UNITED STATES PATENT AND TRADEMARK OFFICE

10/549,675

Office Action Summary

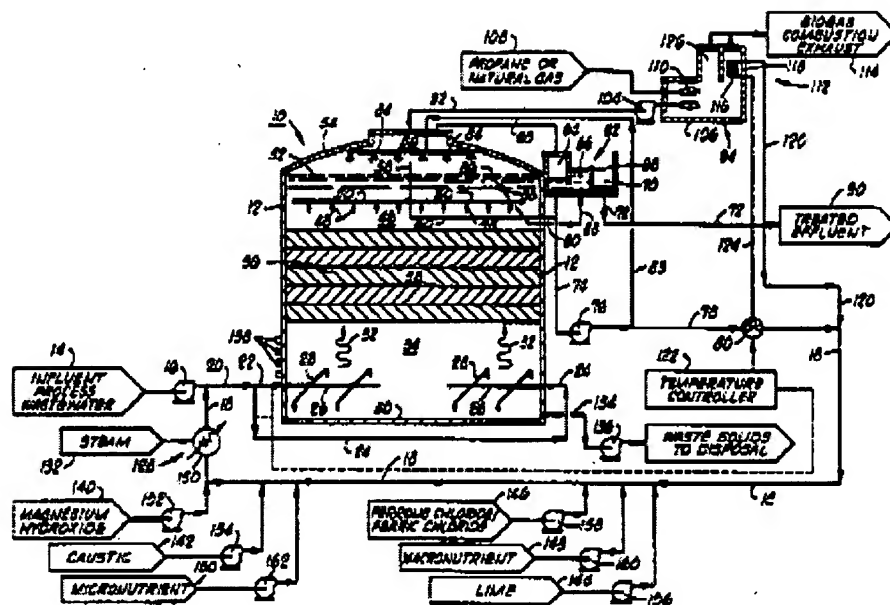
Claims 20-21 are rejected under 35 U.S.C. 103(a) as being obvious over USP 5228995 to Stover and DE 196 10 056. Stover (shown below) describes a waste water treatment reactor having means for generating biogas which upflows through the bed, and scum removal means described at col 2 lines 54-56 and col 10 lines 61-63. The statement of intended use, i.e., to be used in performing the claim 1 invention, was carefully considered, but found upon such careful consideration to be non-limiting of the

structure of the claimed apparatus. The claim is directed to an apparatus, not a method of use thereof.

DE 196 10 056 describes injection of air into a biogas-generating bed bioreactor. It would have been obvious to have done so for the reasons given in DE 196 10 056 for doing so.
